Flight Procedure Tracking Form		Action: AMENDMENT	Task Type: IAP	Date Open: 04/09/2018	Task #: 2018012310410401002	Request #: 20180123104104
Procedure: RNAV (GPS) RWY 15 AMDT 1			Airport ID: KTBN	Airport: WAYNESVILLE-ST ROBERT RGNL FORNEY FLD		Reimbursable #: NO
City: FORT LEONARD WOOD	ST: MO	GPS #:	Estimated Chart Date: 08/15/2019		FICO #: 1225795	
Fac ID: N/A		Fac. Type:			Specialist: LIAM DONAHUE	
Procedure Review						
	Rec'd	Rel'd	Full Name	Comments		
Lead:	12/06/2018	03/15/2019	DAVID SAUER	QUALITY Digitally signed by		
QA:	03/15/2019	03/18/2019	KISSY MAXFIELD	24 DAVID W SAUER		
Liaison:	03/18/2019	03/19/2019	MARY MCDONALD	CHECKED Apr 24, 2019		
Procedure Comments: ENROUTE-NON Remark Type: INFORMATION ASSIGNED MAG VAR, TBN: OLD 3E-NEW 0. CONTACT: DON LANIER, AJV- A431 MANAGER, 405.954-8242 04/22/19: THIS IS AN UPDATED COPY OF THE FORM DEVELOPED ON 01/08/2019. 1. CHANGED ROUTINE REQUIRED EFFECTIVE DATE FROM ROUTINE TO HARD DATE OF 8-15-19.

RNAV (GPS) RWY 15

WAYNESVILLE-ST ROBERT RGNL FORNEY FIELD (TBN)

Proposed Procedure Changes at Ft. Leonard Wood, (KTBN) Missouri

RNAV (GPS) RWY 14

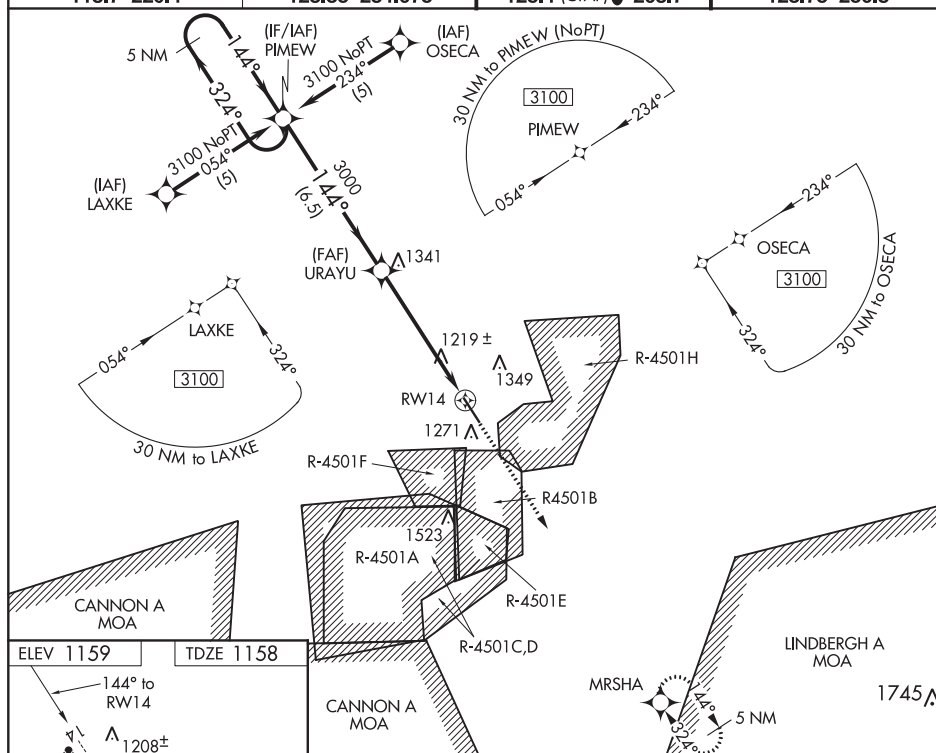
- **NDB Rwy 32** – cancel Instrument Flight Procedure (IFP) currently not being flown.
- **RNAV (GPS) Rwy 15** - Delete LAXKE and OSECA Initials, Remove LAXKE and OSECA Terminal Arrival Area (TAA) Base Legs and replace with the I design TAAs (two halves, one Procedure Turn (PT) Required, one No PT)
